CERTAIN 2016 MODEL YEAR FOCUS AND C-MAX VEHICLES — LEFT-HAND UNDERBODY APRON WELD INSPECTION AND REPAIR

OVERVIEW

FIGURE 2

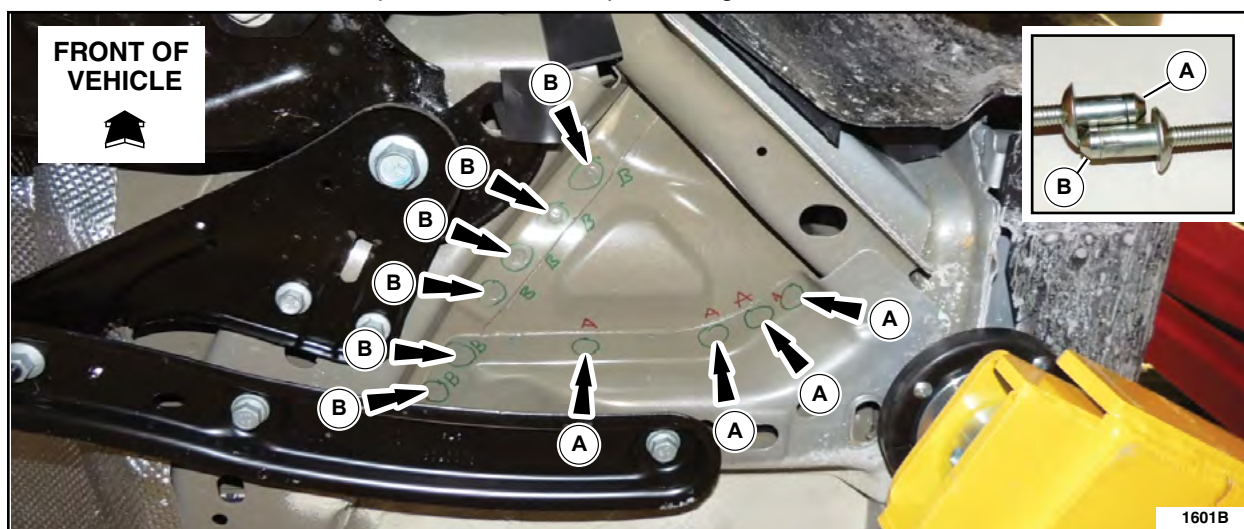
NOTE: Figure 2 shows a vehicle with ten (10) correctly applied factory spot welds. On the affected vehicles, these spot welds are inadequate or missing, and were replaced with rivets. Each spot weld location point must contain a rivet. See Figure 2.

2. Locate the rivets installed into the floor pan seam, under the vehicle behind the LH front tire. Inspect the rivets for proper installation. See Figures 2, 3a and 3b.
 - If the rivets are **installed and seated properly in each location**, no further action is required. See Figures 2, 3a and 3b.
 - If any of the rivets are **installed but seated improperly**, proceed to Repair Procedure on Page 3. See Figures 2, 3a, and 3b.
 - If a rivet is **not installed** in any of the ten (10) locations shown in Figure 2, install the correct rivet(s) as needed. Drill a hole in the appropriate location(s) using a suitable 17/64 in (6.75 mm) drill bit. Proceed to Repair Procedure, Step 6 on Page 5.

- If replacing rivets at "A" locations, install a short "A" rivet. See Figure 2.
- If replacing rivets at "B" locations, install a longer "B" rivet. See Figure 2.

FIGURE 7

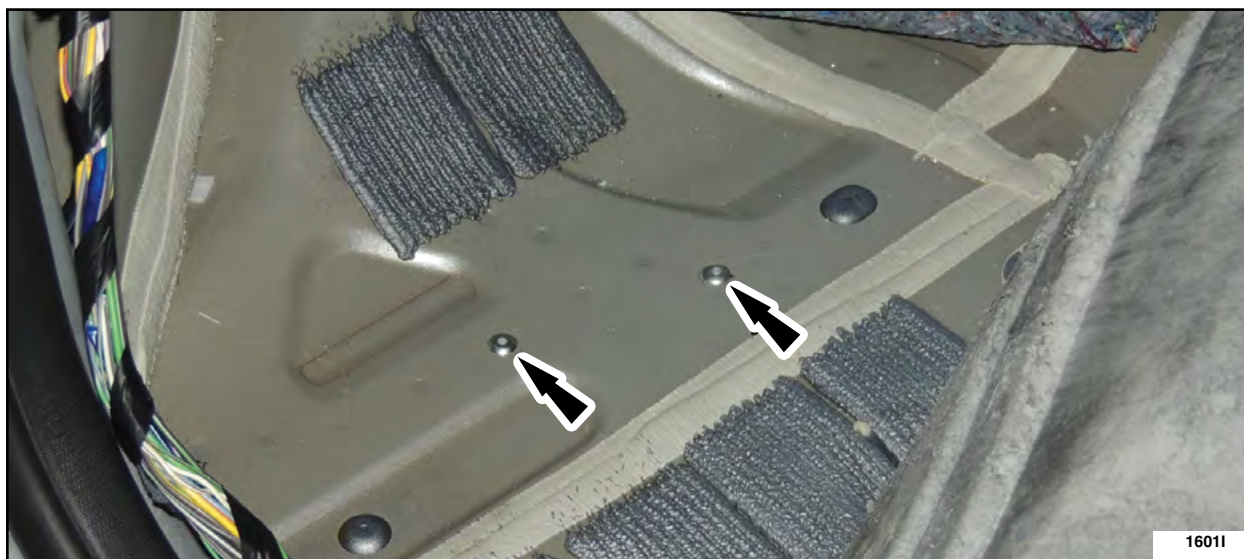
7. Install the rivets using a suitable rivet gun, from inside the vehicle. See Figure 7.
